Lower Yonge Precinct

Municipal Class Environmental Assessment Study
Consultation Summary from the Public Information Centre

Yonge Street: Railway Corridor (Facing North)

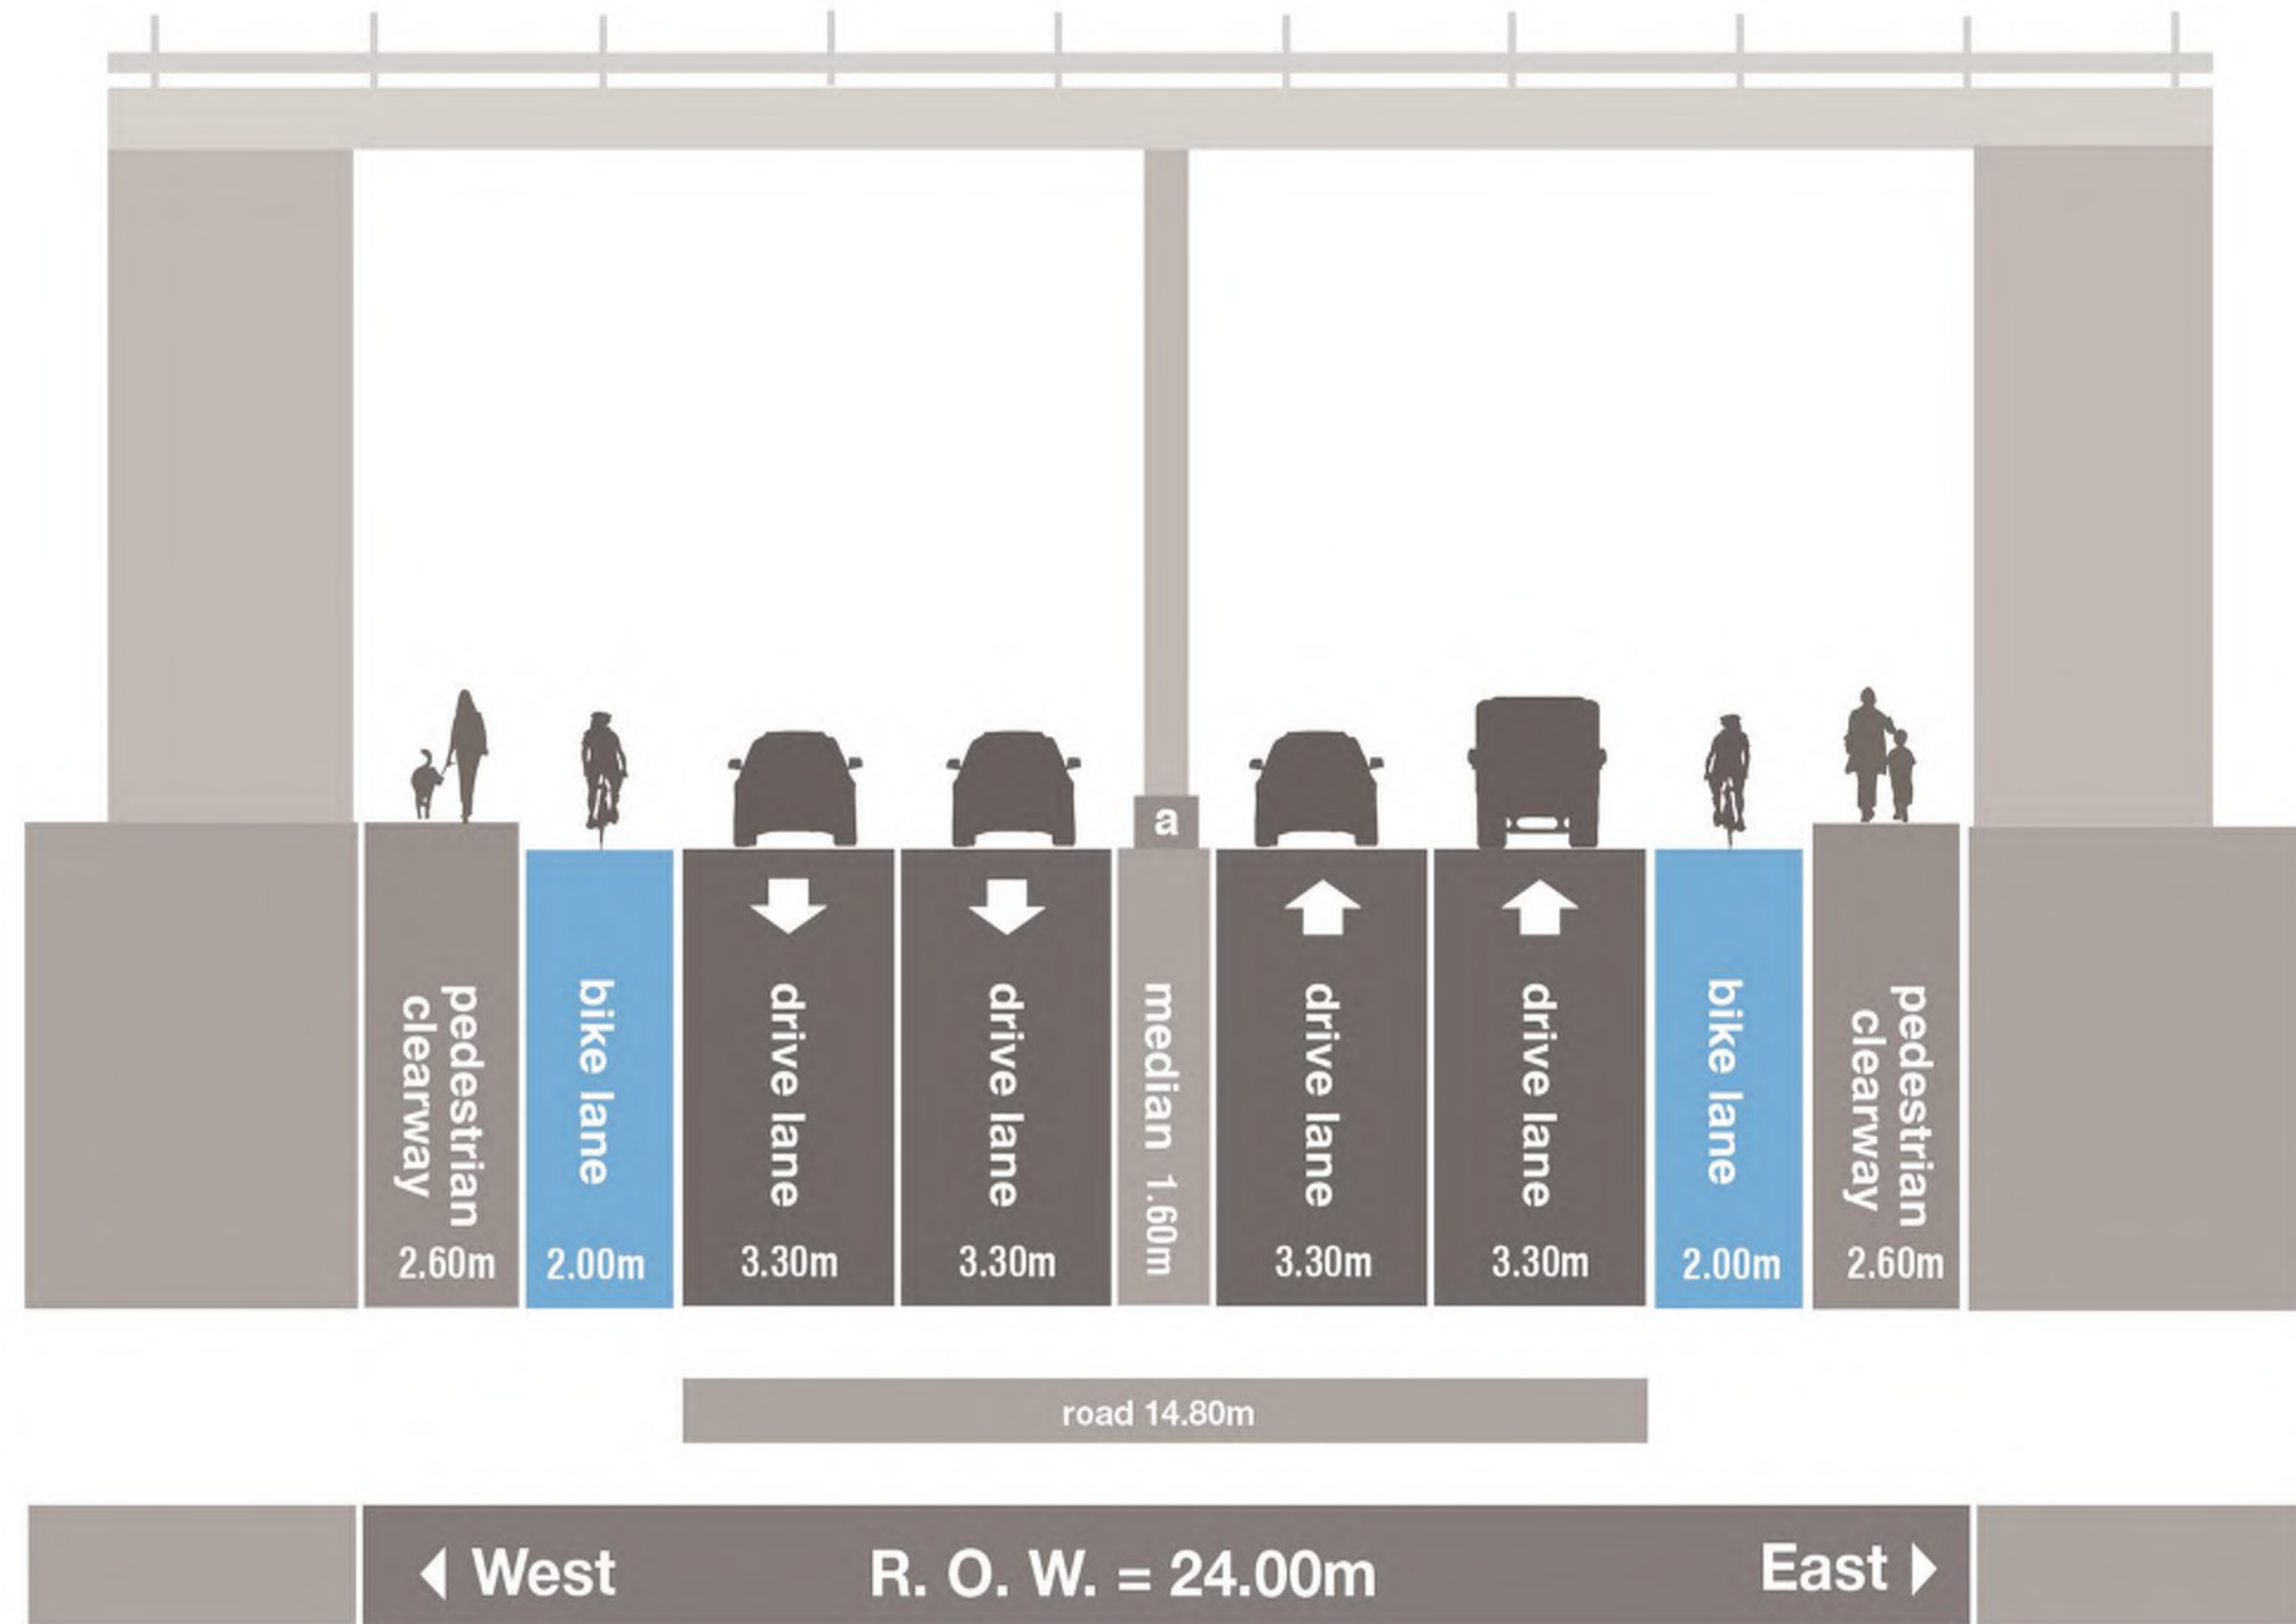
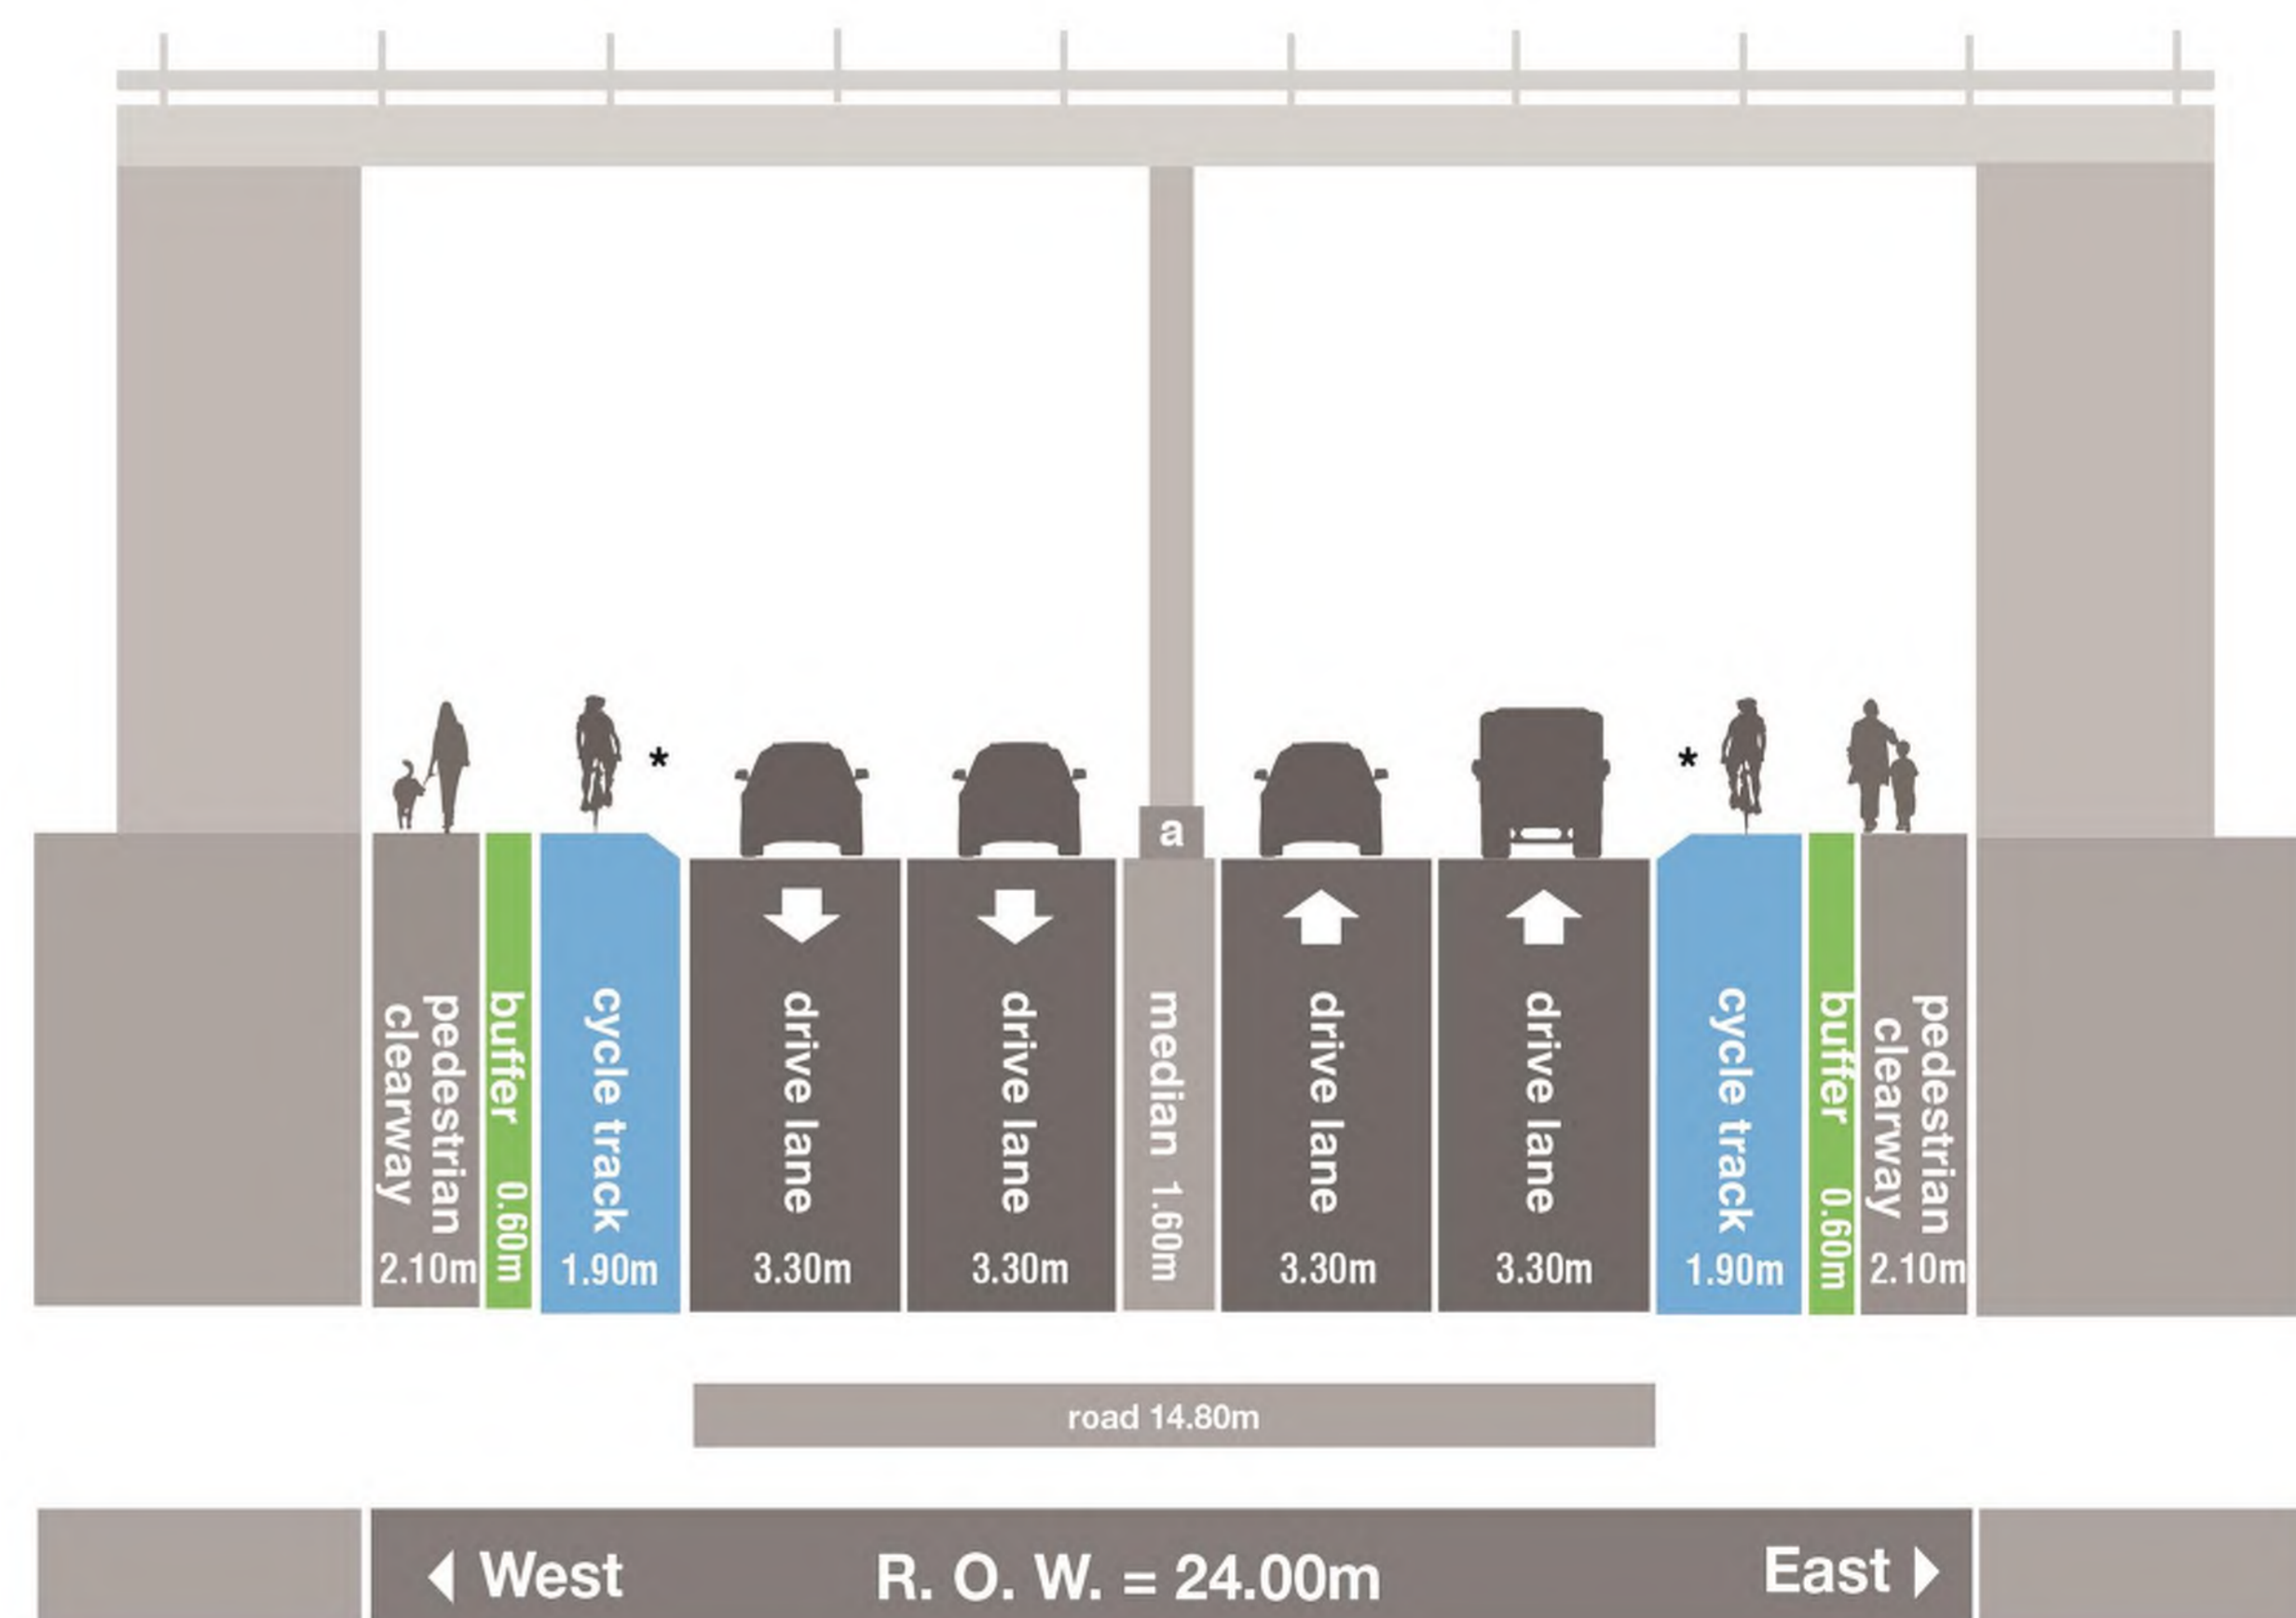
Can there be more separation for the cyclists from the traffic by moving the cycle track between the planting zone and the pedestrian clearway?

The proposed cycling facilities with mountable curbs elevated from the roadway provide an element of separation. The preliminary preferred alternative along Yonge Street through the rail corridor will provide an increased level of comfort and safety when compared to the existing bike lanes along Yonge Street.
